PEP2040 scrutinized by Forum Energii

Comments and recommendations on Poland's Energy Policy until 2040

WARSAW, JANUARY 2019

Figure 1. Comparison of the level of emission reduction from the energy sector – scenarios: **PEP2040** (according to the Ministry of Energy), **PEP2040 (e)** and **alternative scenario**

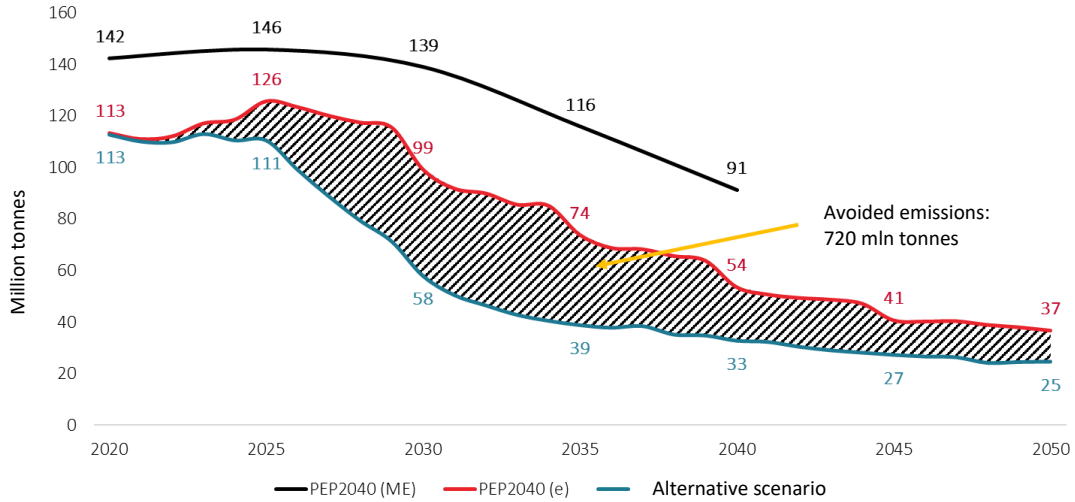
- The potential for reducing CO₂ emissions in 2030 is larger than 30% presented in **PEP2040**.
- In the scenario without nuclear power, Poland (only in the power industry, including CHP plants) can reduce emissions by more than 29% in relation to the level assumed in **PEP2040 (e)**, which is confirmed by the result of the *alternative scenario* analysis.

- **PEP2040** should set more ambitious emission reduction goals.
- Cross-border connections should be included in the plan to cover future electricity demand.
- The potential of energy efficiency and RES in emission reduction should be taken into account.
